Sea Link

Document 9.34: Applicant's Comments on Relevant Representations

Planning Inspectorate Reference: EN20026

Version: A
November 2025

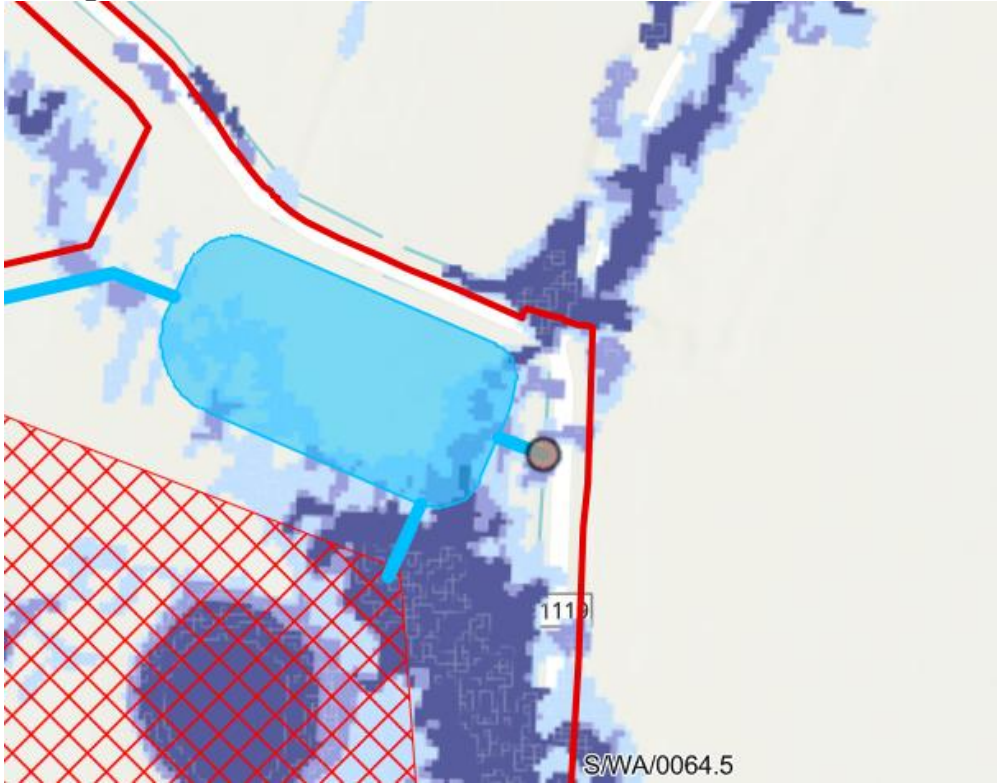
2.4.27.1	EA – Flood risk of ordinary watercourse crossings ID: EA090 Environmental Statement APP-051 6.2.2.4 Part 2 Suffolk Chapter 4 Water Environment APP-292 6.8 Flood Risk Assessment Section/ pages/ table reference: 4.3.13 (APP-051) Appendix A (APP-292) Issue Limited detail is provided on the flood risk impacts of ordinary watercourse crossings. Of particular concern are the permanent culverted crossings at locations S/WA/0064.5 and S/WA/0064.4 and the temporary crossing	Solution Ordinary watercourse crossings should be sized appropriately such that they do not increase flood risk. Ensure that crossings S/WA/0064 and S/WA/0057 are designed such that they can easily convey the design flood flow for these watercourses. This will help to ensure they do not increase flood risk elsewhere and particularly to the B1119 and allow for access to be maintained during times of flood. Hand calculations, for example using the CIRIA Culvert Screen and outfall manual (C786), or a simple 1d model, should be developed to ensure the culvert crossings are appropriately sized, and do not increase flood risk in the design flood event. Additional comments:	Application Document 7.5.3.2 CEMP Appendix B Register of Environmental Actions and Commitments (REAC) [APP-342] includes several commitments linked to culvert design, specifically W04 requires that culverts will be sized to reflect the span width and the estimated flow characteristics of the watercourses to be crossed under peak flow conditions and that culverts will be kept free from debris. This commitment will prevent increases in flood risk at ordinary watercourse crossings. The Applicant has engaged with the Lead Local Flood Authority to discuss the proposed crossings of ordinary watercourses in Suffolk. The sizing calculations would be provided by the appointed contractor for approval by Suffolk County Council as the Lead Local Flood Authority, who are the consenting authority for the S/WA/0064.5, S/WA/0064.4 and S/WA/0057 culvert crossings.

Reference	Summary of relevant representation	Recommendation	Applicant's response
	at S/WA/0057 which is within Flood Zone 3. Impact Flood risk could be increased as a result of new crossings	Change in flow regimes of Ordinary Watercourses and Main Rivers at the converter station site and at watercourse crossings have been scoped out of the assessment. There is no watercourse shown on the Detailed River Network (DRN) at crossing S/WA/0064.5 although inspection of aerial photography shows the continuation of the drainage ditch along the southern side of the B1119 in this location. It is difficult to identify a catchment for this watercourse in the FEH webservice given the artificial nature of the channel and flat nature of the surrounding topography. Derivation of the catchment to the approximate location of crossing S/WA/0064 using 1 metre resolution Lidar data captured in 2023 reveals an area of 1.9 kilometres squared (km²) (see figure 1 below). For the crossing at location

Reference	Summary of relevant representation	Recommendation	Applicant's response
		4(S/WA/0057) the catchment within the FEH webservice is clearer with a catchment area of approximately 1.3km²
